UNITED STATES PATENT AND TRADEMARK OFFICE

10/534,250

Office Action Summary	Application No.	Applicant(s)	
	10/534,250	AKAGI, HIROFUMI	
	Examiner	Art Unit	
	Adolf Berhane	2838

DETAILED ACTION

FIG. 8

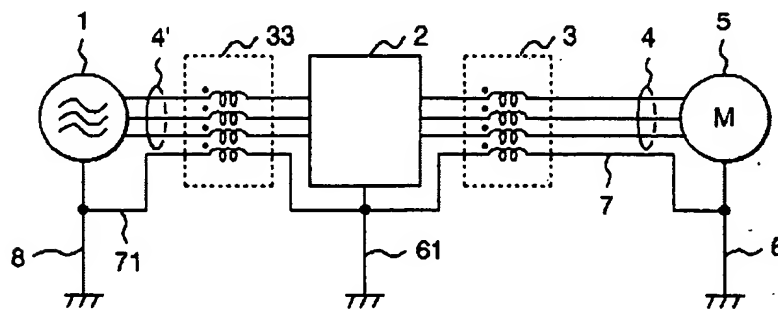
5. Applicant's arguments filed 2/14/07 have been fully considered but they are not persuasive. In response to Applicant's argument that Figs. 9-13 of Ayano, line 7 does not connect a neutral point of motor 5 to a reference potential point. The neutral point of motor 5 is at element 6, which, as illustrated in Figs. 9-13 of Ayano, is not connected by line 7 to the reference potential point. Applicant's attention is directed to Fig. 8 shown below which clearly shows the neutral point of motor 5 elements 6, which is connected to line 7.

FIG. 11

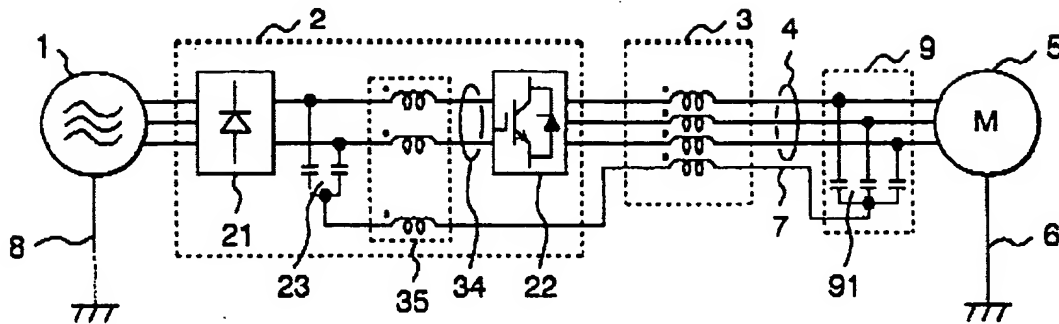
Applicant further argues that the common mode choke is not connected to the direct current voltage input. Applicant's attention is directed to Fig. 11, which shows common

mode choke (35) connected to the input of the direct current voltage.
